Questions and Answers
RFQ No. SCA52515Q0027
U.S. Embassy Ottawa Technical Security Upgrade

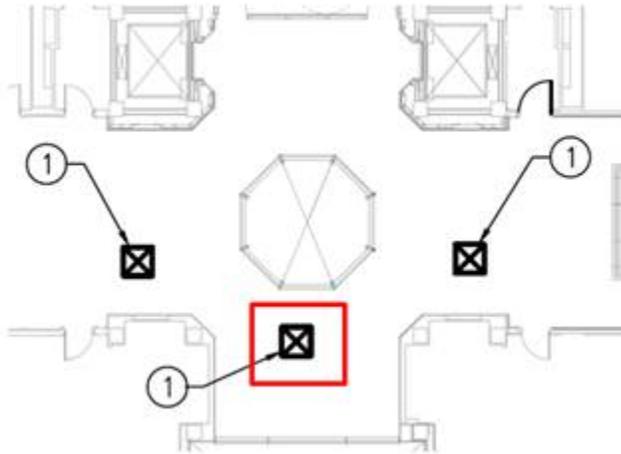
3. Q: Pertaining to the ceiling hatches to be installed in the Chancery building, is the western center hatch on the fourth floor required as per the drawings? The location of the hatch is approximately 50 feet above the screening floor and would be extremely costly to install.

A: As discussed during the site visit, the third ceiling hatch on the fourth floor was indeed an oversight in the drawings and will not be required. The Contracting Officer's Representative (COR) will be working to get revised drawings, but for the purposes of the offerors' proposals, this item should not be included in the labor requirements. This should not alter the contract wording or Statement of Work in any way, to make it clear. On the attached drawings, it is the center hatch located on page C3.04. The elimination of this hatch should drop any required scaffolding from the lobby level, reducing the costs and effort.

As soon as the COR receives the revised drawings from Washington, a copy will be provided to all offerors, So far all required information were provided verbally during the site visit and in writing for offerors' consideration in preparing their proposals. Below is a blown up sketch indicating the hatch to be excluded from the drawings on C3.04.
